Intersection ID: 27325	Main Street: TILLEY_MORRIS_RD	Cross Street: N/A	Location:	N
ADA ID: DE3BA7D4DBB2	Ramp Type: Perp	Initial Pass/Fail: Fail	Overall Compliance: No	Severity Score: 1.25

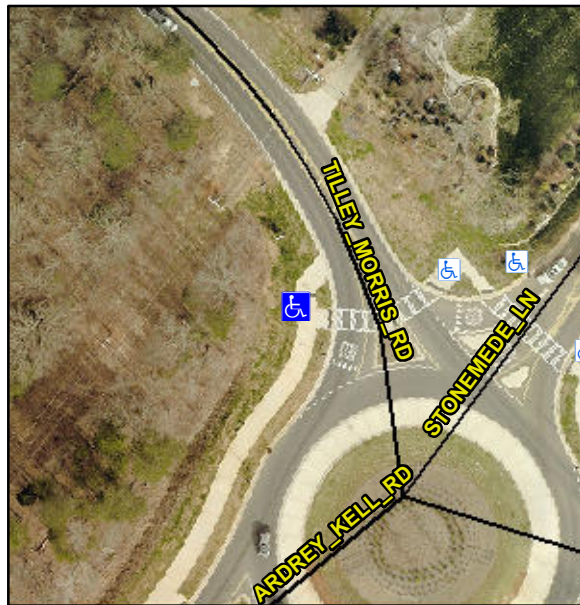
## Not Found, R304.5.3

Compliance	Description	Data	Compliance	Description	Data
N/A	Ramp Length (in)	96.0	Yes	Ramp Slope (%)	7.0
Yes	Ramp Width (in)	108.0	No	Ramp XSlope (%)	4.2
N/A	Flare Type LT	N/A	N/A	Flare Type RT	N/A
N/A	Flare Slope LT (%)	N/A	N/A	Flare Slope RT (%)	N/A
N/A	Flare Traversable LT?	N/A	N/A	Flare Traversable RT?	N/A
N/A	Landing Length (in)	N/A	N/A	DWS Provided?	N/A
N/A	Landing Width (in)	N/A	N/A	DWS Contrast?	N/A
N/A	Landing Slope (%)	N/A	N/A	DWS Length (in)	N/A
N/A	Landing X Slope (%)	N/A	N/A	DWS Full Width?	N/A
N/A	Landing Curb? (Y/N)	N/A	N/A	DWS Offset (in)	N/A
N/A	Shared Landing?	N/A			
N/A	Gutter Ponding?	N/A	N/A	Gutter Slope (%)	N/A
N/A	Gutter Lip Ht (in)	N/A	N/A	Gutter X Slope (%)	N/A
N/A	Painted X Walk1?	Yes	N/A	Painted X Walk2?	N/A
	X Walk 1 Direction	To E		X Walk 2 Direction	N/A
N/A	X Walk 1 Width (in)	112.0	N/A	X Walk 2 Width (in)	N/A
	X Walk 1 Slope (%)	0.9		X Walk 2 Slope (%)	N/A
	X Walk 1 X Slope (%)	3.1		X Walk 2 X Slope (%)	N/A

### Remove & Replace Entire Ramp.
